## **Camden TRO Torrington Place to Tavistock Place Inquiry**

# Written Representation pursuant to the 1994 Rules Section 24. (10)Statement of Case by Michael Gwinnell

# **APPENDIX – Camden map of alternative westbound routes**

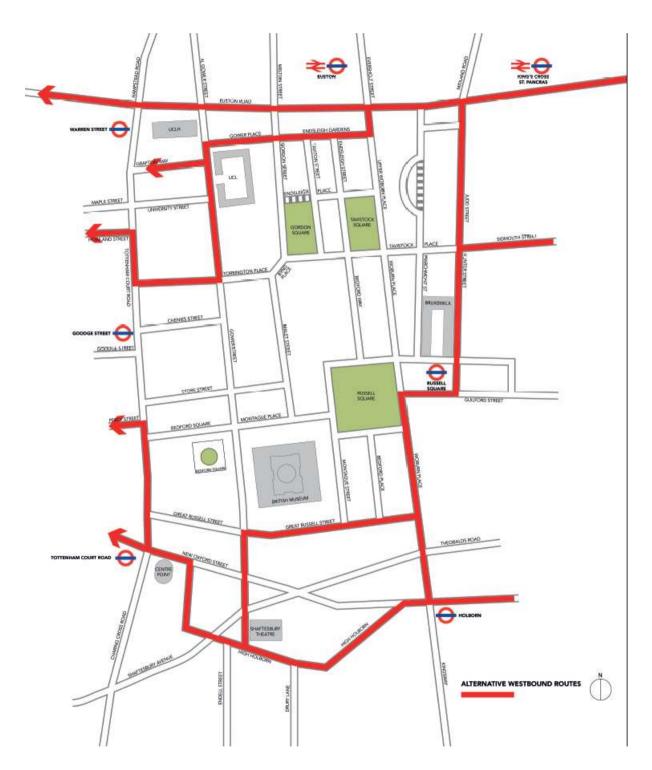
#### If the draft TRO is to be approved the following provision should be deleted:

"Require any motor vehicle proceeding westwards in Tavistock Place to turn left on reaching the junction with Hunter Street and Judd Street."

The TT scheme consultation map showing alternative westbound routes included a prohibited right turn from Tavistock Place into Judd Street. (See attached Appendix taken from <u>http://www.camden.gov.uk/ccm/cms-service/stream/asset?asset\_id=3365683</u>)

The draft traffic order (to which I have objected in this regard) retains this as a prohibited right turn even though there seems no justification for it, as the traffic light phasing prevents any conflicts with eastbound traffic at this junction. There is an alternative route into Judd Street via Wakefield Street and Handel Street but this requires a right turn into Hunter Street against the traffic. It is noted that in due course if the Judd Street proposals in conjunction with the North/South Cycle Superhighway are implemented this will prevent left turns from Judd Street into Euston Road, thus making this alternative route infeasible, but this does not prevent the right turn being permitted until the Judd Street proposals are implemented.
